Denim Attires Ltd. (11366)

Nimtoly, Shilmon, Tongi, Gazipur.

28.06.2014

2nd Priority 2 Concern

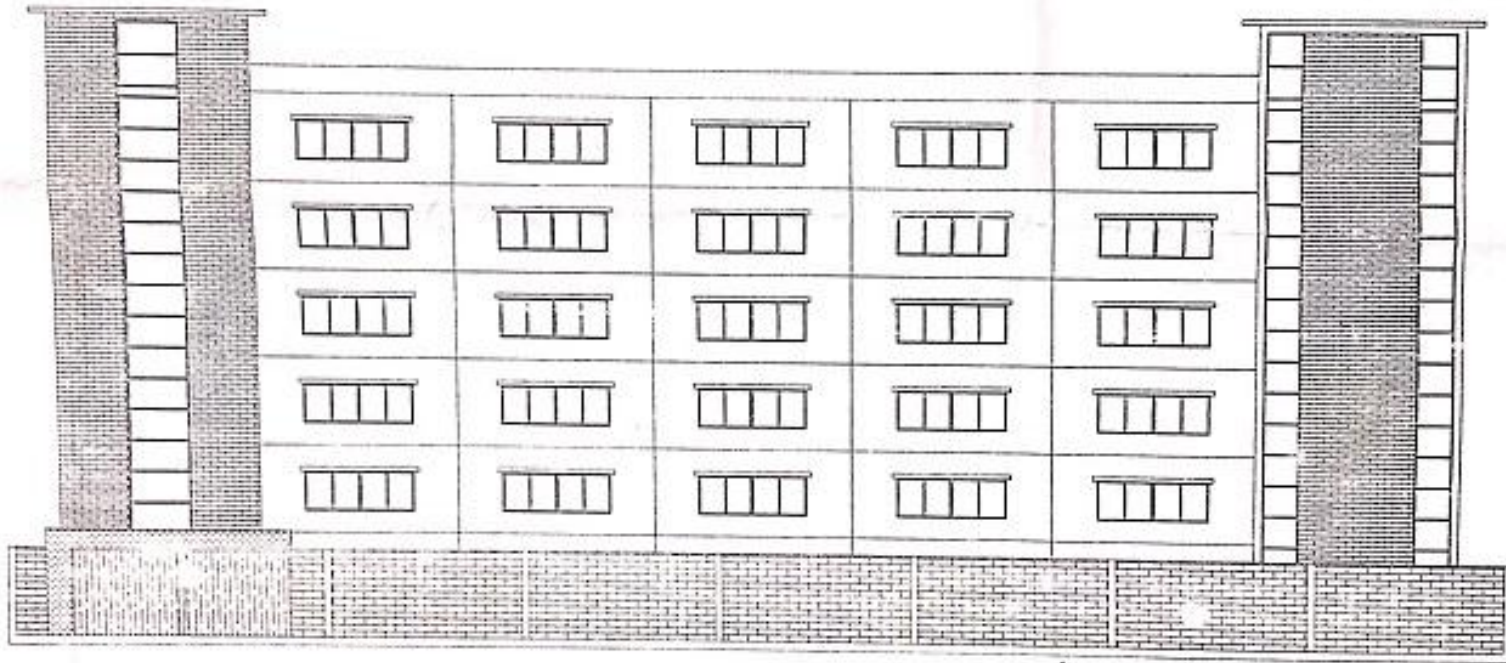
Exterior steel staircase of the main building is poorly designed.
